THE COUNTY OF CHESTER

Re: Preliminary Land Development - Brandywine View Apartments
City of Coatesville - LD-12-21-17016

A preliminary land development plan entitled "Brandywine View Apartments", prepared by Pennoni Associates Inc. and dated October 13, 2021, was received by this office on December 2, 2021. This plan is reviewed by the Chester County Planning Commission in accord with the provisions of Section 502 of the Pennsylvania Municipalities Planning Code. We offer the following comments on the proposed land development for your consideration.

**Detail of "Brandywine View"
2005 Land Development Plan**

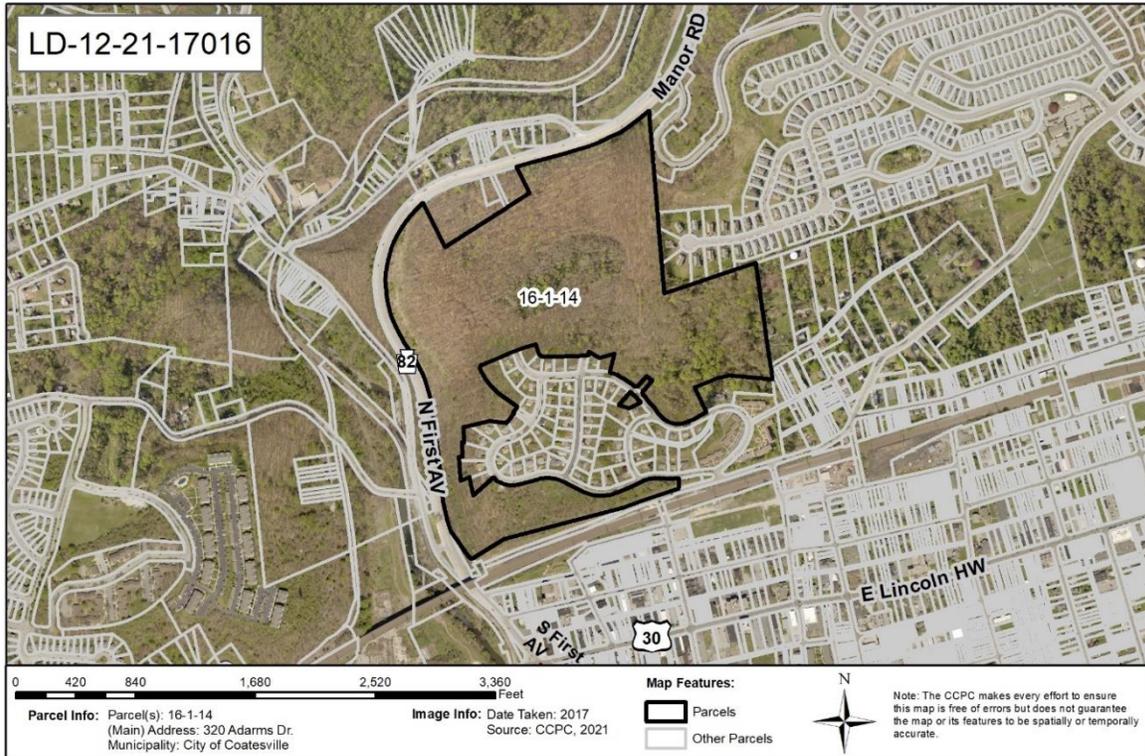
On September 28, 2005, the Chester County Planning Commission reviewed a proposed land development for this site, which included 569 residential units on a 74.7-acre tract (refer to CCPC # 11884). A detail of that proposal, which includes the site of the applicant's current land development, is shown below:

Detail of the Current Brandywine View Apartments Preliminary Land Development Plan

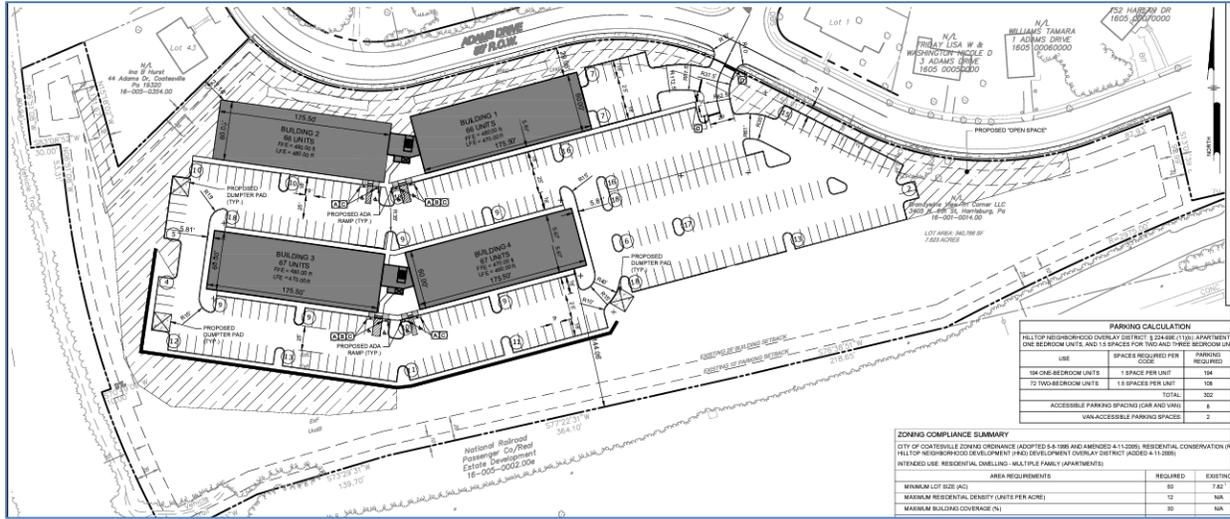
- The City should verify that the applicant is meeting the HND Overlay District’s open space and recreational area requirements. The proposed open space areas are peripherally-located and do not appear useable.

10. The area to the north consists of much lower-density residential developments, including single-family dwellings. We suggest that the applicant conduct a shadow analysis to predict how the proposed multi-story buildings will affect the neighborhood to the north.

11. The parking at the eastern section of the site is somewhat remote from the buildings. We suggest that the applicant consider reorienting the buildings to create more convenient pedestrian access from the parking areas.

12. We suggest the applicant consider eliminating at least one of the proposed buildings or reconfigure the buildings to limit environmental impacts and provide more usable and centralized open space and recreational areas. Reconfiguring the buildings to allow parking underneath would decrease the footprint for the required parking, provide room for usable open space, and limit the environmental effects on the site, such as on the steep slopes and woodlands.

For example, the applicant could place the buildings in terraces and locate parking under the structures. Also, the applicant should consider the potential to break up the four large structures into more smaller structures that would create less site disturbance and visual effects on the areas to the north. Orienting the buildings in a north-south configuration could also reduce site disturbance and visual effects.
